RotorSport UK Ltd

Service Bulletin

Title: Stick vibration reduction.		
SB No.: 061 Iss 1	Related documents MC No: MC-209 CCAR No.: None	Compliance Category: OPTIONAL or RECOMMENDED or MANDATORY
Applicability		
Aircraft type & model MT-03 MTOsport Calidus	Aircraft serial Nos. effected Any Any prior to RSUK/MTOS/048 Any prior to RSUK/CALS/022	
This form is the response from RotorSport UK Ltd either against a problem found in the product in service requiring a containment or rectification action, or as service information for aircraft modification incorporation. For help, contact RotorSport on 44(0)1588 650769, or email info@rotorsport.org.		
<u>Reason and overview of the Service Bulletin (cause of problem if known)</u>		
This service bulletin describes the installation of Pitch/Roll Improvement Kit RSD7218 which reduces the transmission of rotor vibration to the control stick. It is particularly effective with Calidus aircraft (which utilise push/pull control cables) but also provides some benefit for MTOsport and MT-03 aircraft (which use control rods).

View of MT series rotor head. Speed sensor Pitch bolt Roll bolt

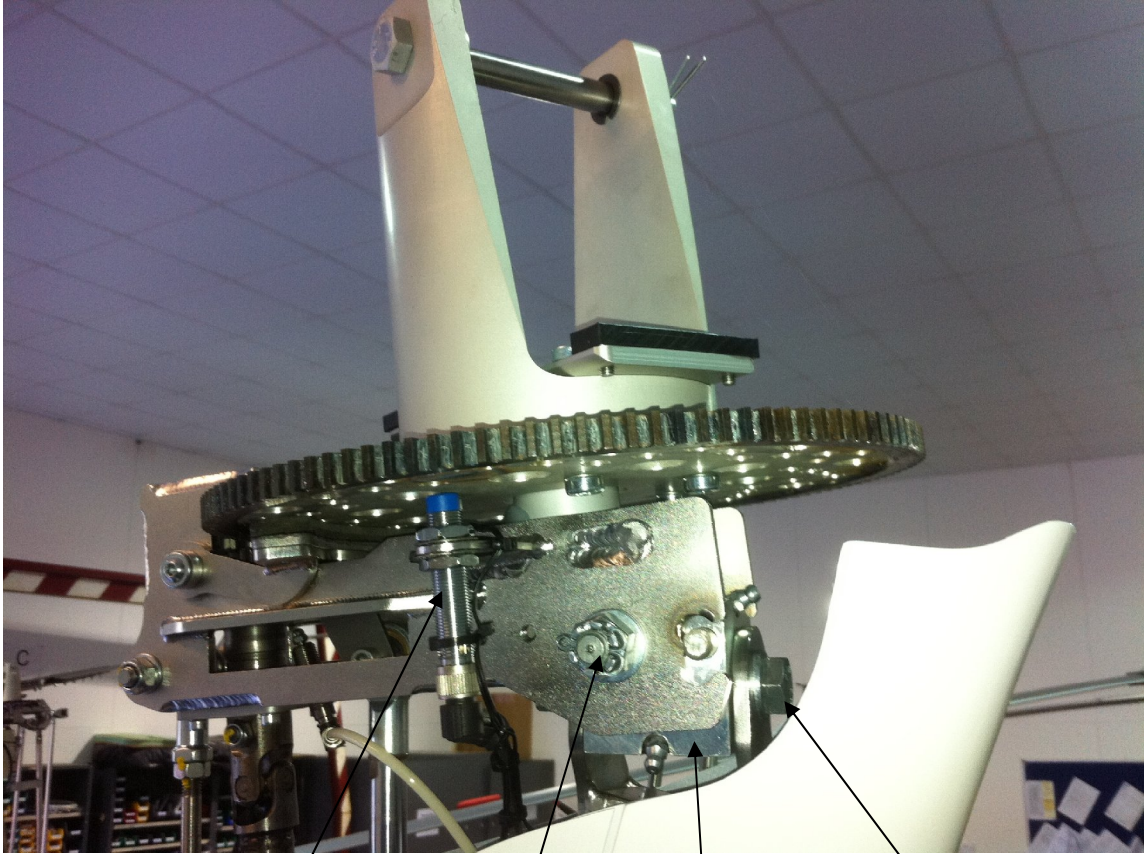
- (i) To remove gimbal block from aircraft
1. Position the aircraft on level ground and apply brakes/chock wheels. Remove the rotor as described in the Maintenance Manual.
 2. Disconnect the rotor rpm sensor and tie the cable safe to one side
 3. Remove the split pin, and unscrew the nut from the pitch-pivot bolt. Remove the washers and the bolt and move the rotor-head clear of the mast
 4. NB: on early aircraft the pivot bolt head may be adjacent to the rotor-speed sensor requiring that the sensor is temporarily removed. Before doing this use a feeler-gauge to establish the clearance between the sensor face and the disk and note the orientation of the sensor. Its face should be clear of the disk by ~2mm.
 5. Remove the split-pin, and unscrew the nut from the roll-pivot bolt.
 6. Remove the washers and the bolt and lift the gimbal block clear.
